**A40 LLANDDEWI VELFREY TO PENBLEWIN IMPROVEMENTS
MR WG AND MRS PM REYNOLDS,**

I refer to your correspondence dated 18 September 2019 in relation to the draft Statutory Orders associated with the Welsh Government's proposals for the A40 Llanddewi Velfrey to Penblewin ("the Scheme").

A40 Llanddewi Velfrey to Penblewin Improvements –

Drawing Title
SCHEME LAND REFERENCING PEN TROYDIN FAWR

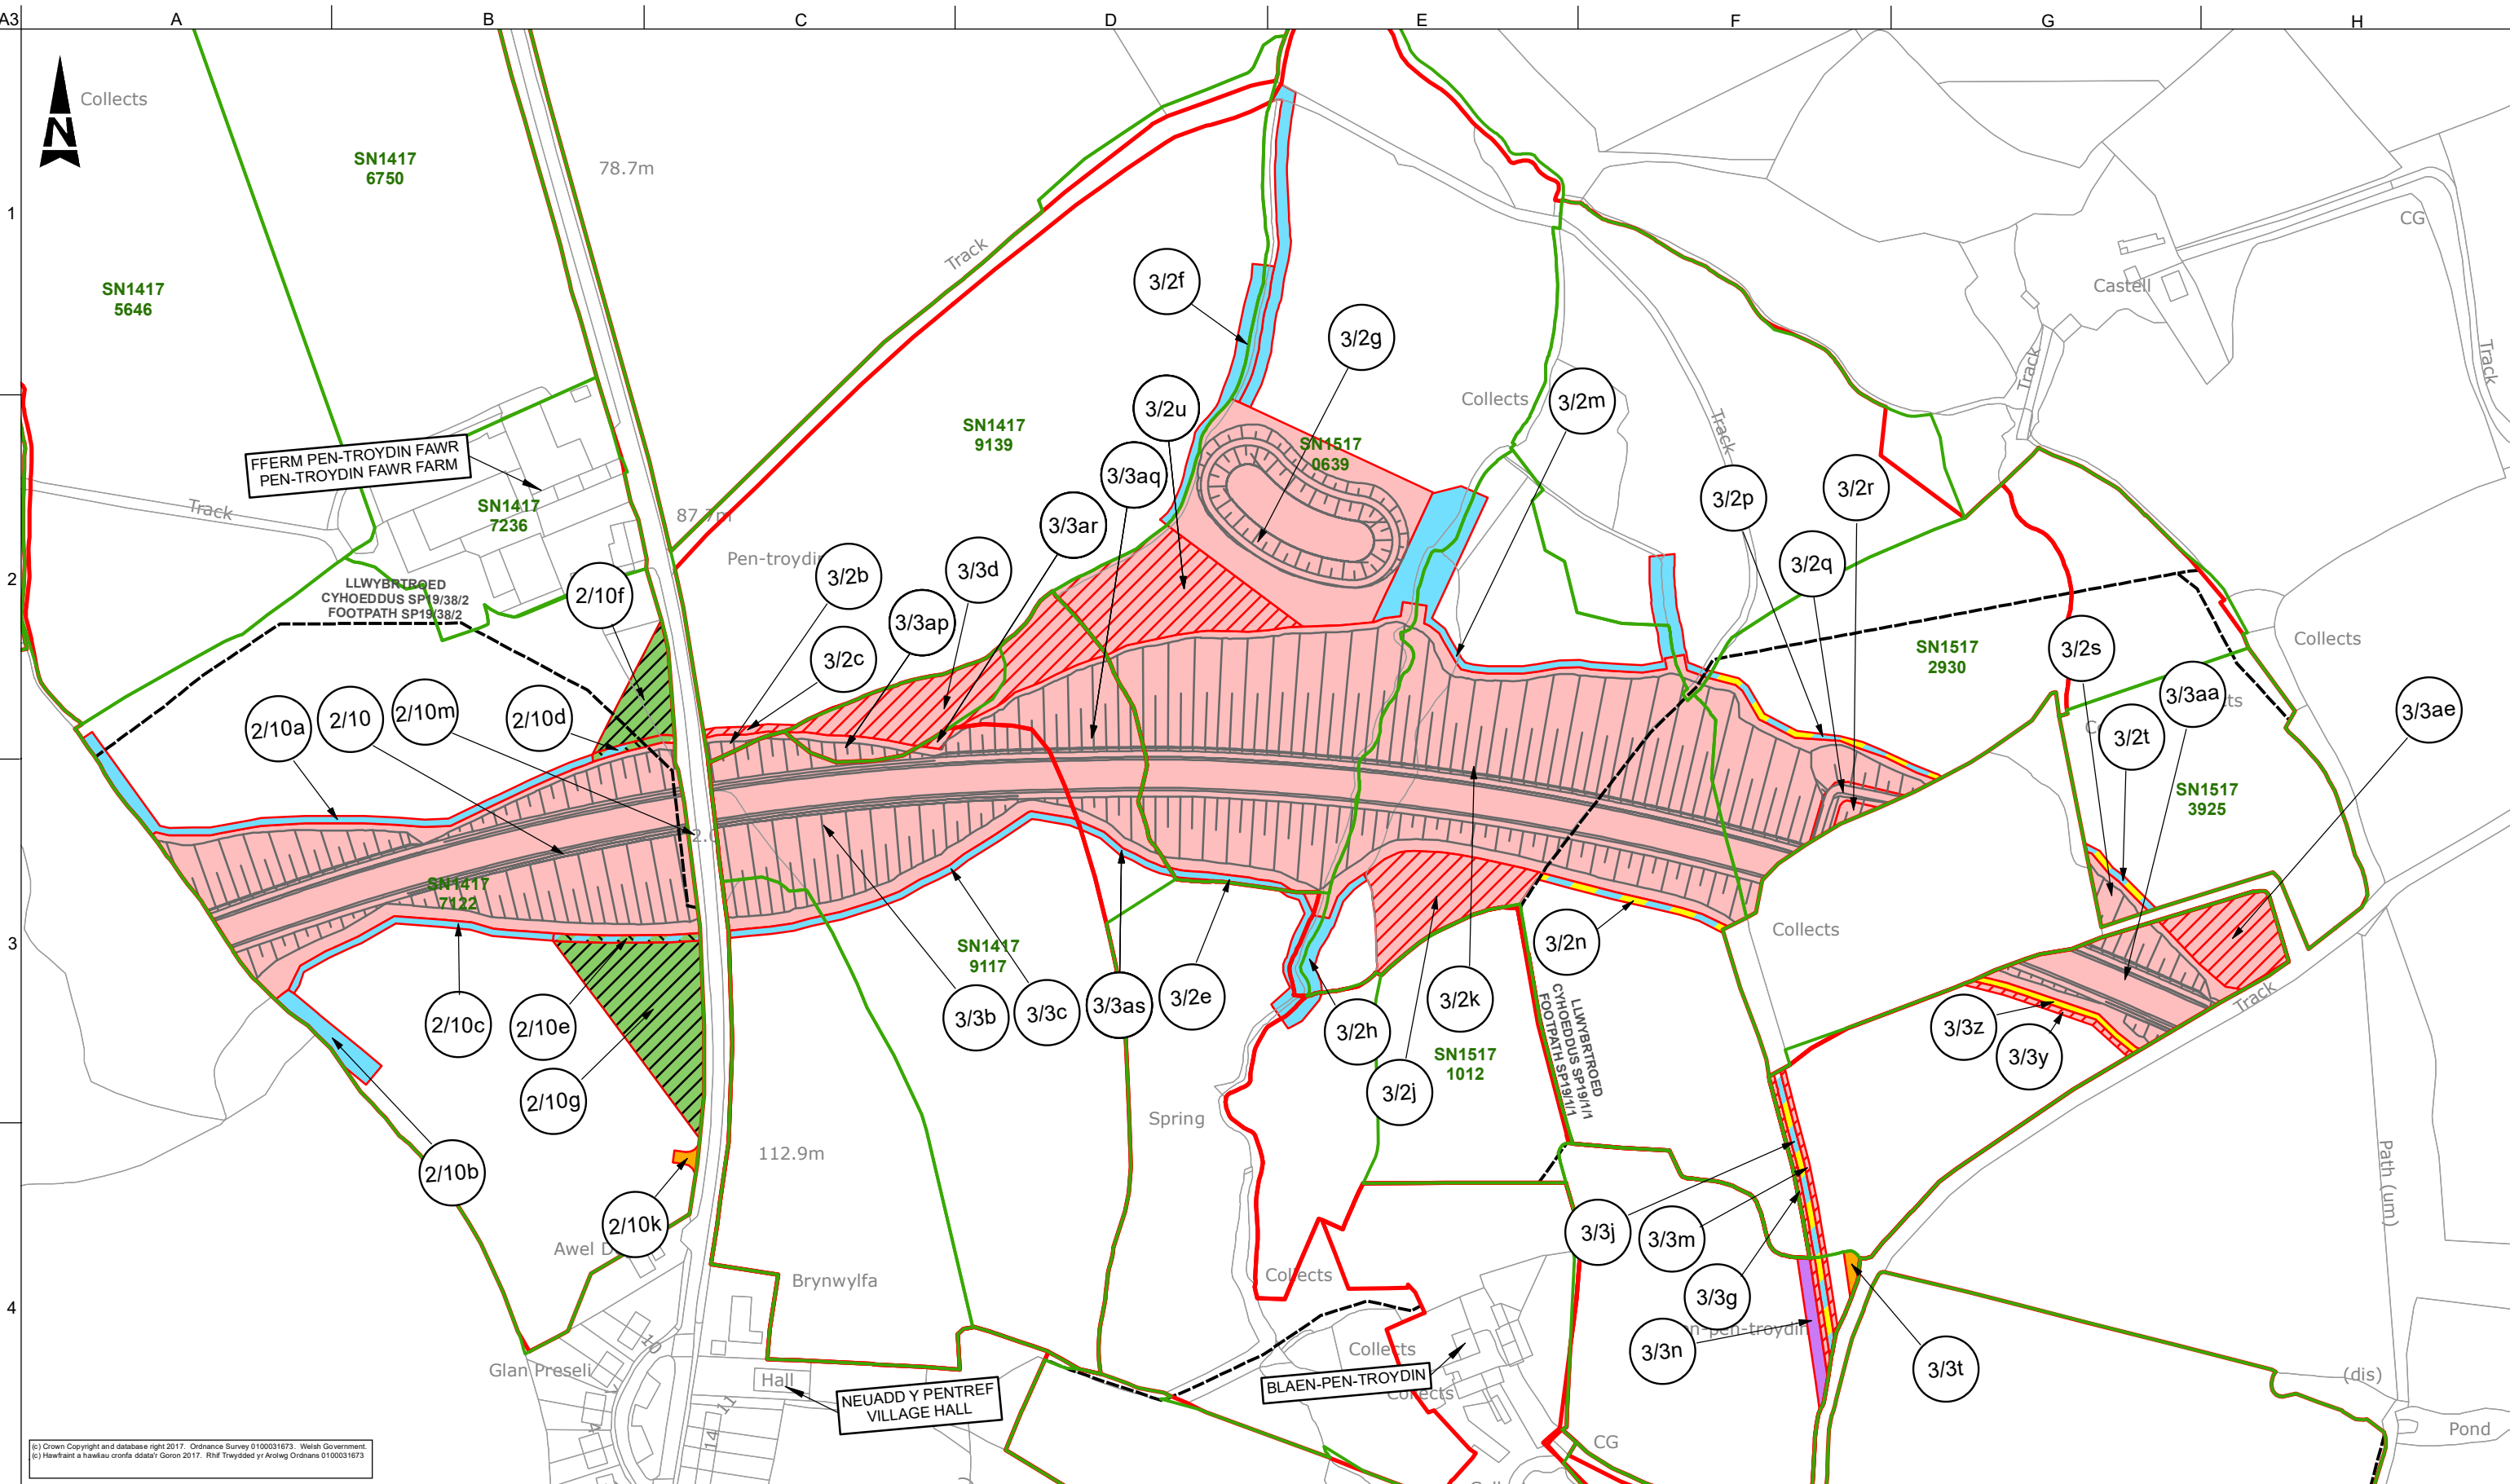
The concerns you raised during this meeting regarding the proposed cattle underpass located at your boundary with Pen-Troydin-Fach Farm were:

1. You would not share use of the proposed underpass due to the risk of transfer of tuberculosis between neighbouring cattle.
2. You could only use the underpass for transferring cattle to the field to the south of the proposed A40 if full separation with the neighbouring farm was provided through the underpass.

In response to your concerns we have reviewed the design and made the following amendments:

1. The underpass proposed will now be for the sole use of Pen-Troydin-Fach Farm. The draft Orders when published will reflect this.
2. Access to your land to the south of the proposed A40 will be via new gated accesses and across the proposed overbridge on Llanfallteg Road.
